**COMMENTS ON  
CHEMOURS' CORRECTIVE ACTION PLAN (DEC. 31, 2019)  
SUBMITTED PURSUANT TO THE CONSENT ORDER IN  
*State of North Carolina v. The Chemours Company FC, LLC*, Case No. 17-CVS 580  
(Bladen County Superior Court)**

**I. Executive Summary**

**Figure 2: PFAS Signatures by Primary Source**

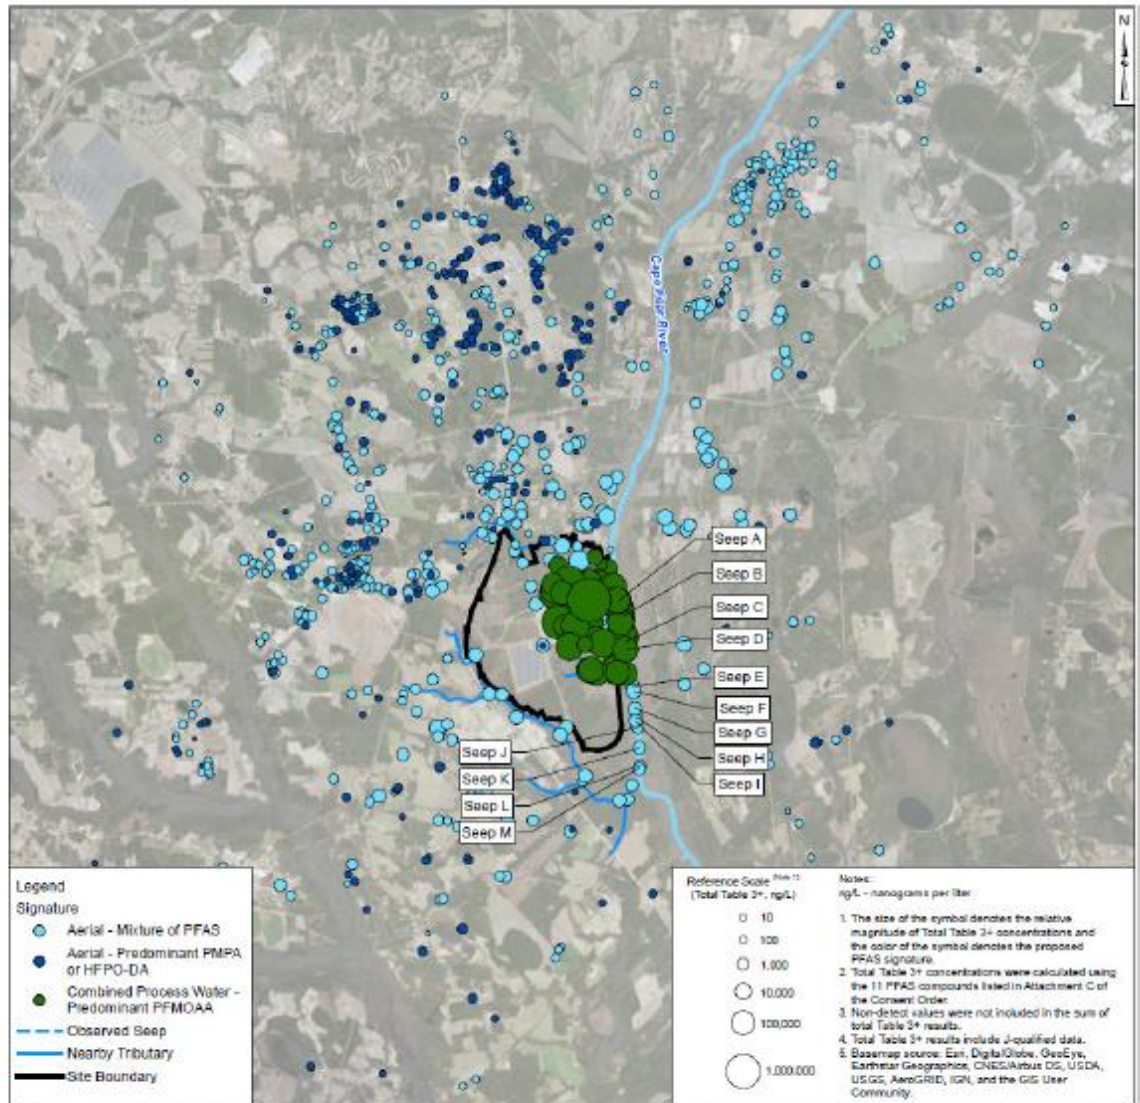
The CAP fails to provide adequate plans and proposals to remediate ongoing PFAS contamination in order to protect DRCs. In some instances, Chemours offers *no solution* to a major source of continuing PFAS contamination (from aerial depositions outside Fayetteville Works), and in others offers proposals that are so tentative and under-investigated as to provide no assurance of any remedial efficacy at all. Nowhere in the CAP has Chemours calculated how long the Cape Fear River will continue to be impacted by PFAS migrating from the Cape Fear River watershed or the seeps at and near Fayetteville Works. Nor has Chemours determined how long the DRCs' water will continue to exceed the 10/70 Action Levels. Given the absence of such critical information, it is safe to assume that Chemours knows that the river and the DRC water supplies will be exceeded for decades, if not indefinitely.

**Figure 1. GenX Concentrations in Samples Collected from Outfall 002 at Chemours Fayetteville Works.**

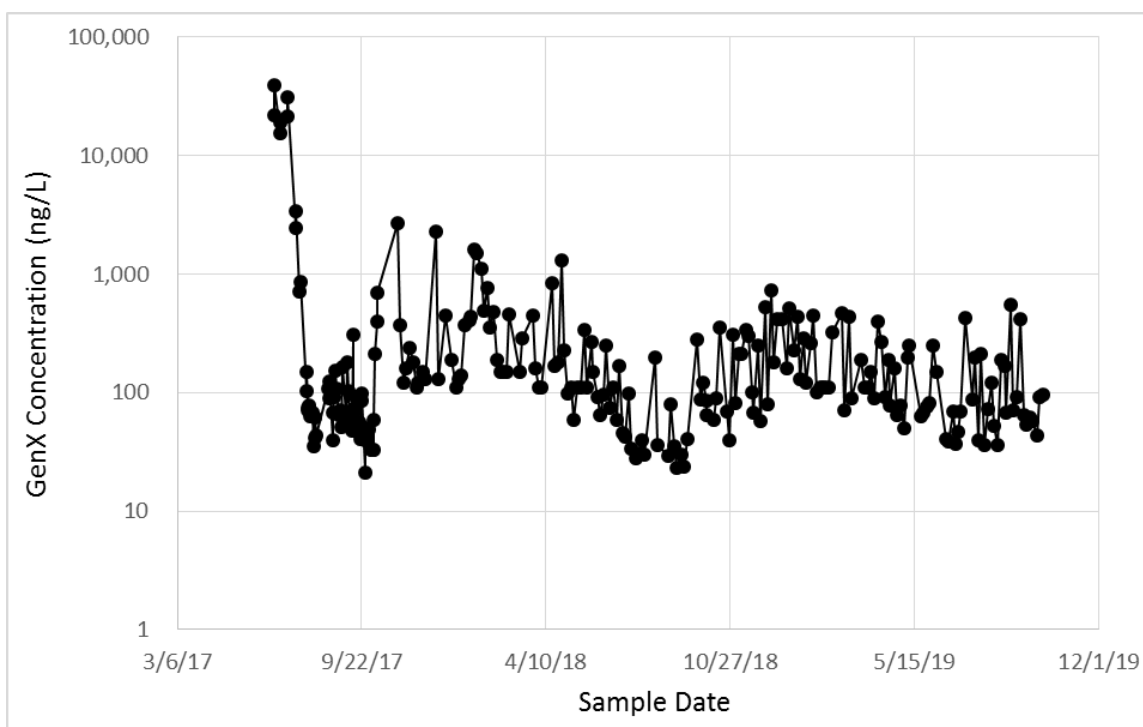
Further, although the ongoing *discharge* of PFAS-containing water from Outfall 002 has been reduced, the outfall is still providing about 5 percent of the mass-loading to surface water in the adjacent Cape Fear River. And the concentration of GenX and other PFAS in samples collected from Outfall 002 remain elevated.
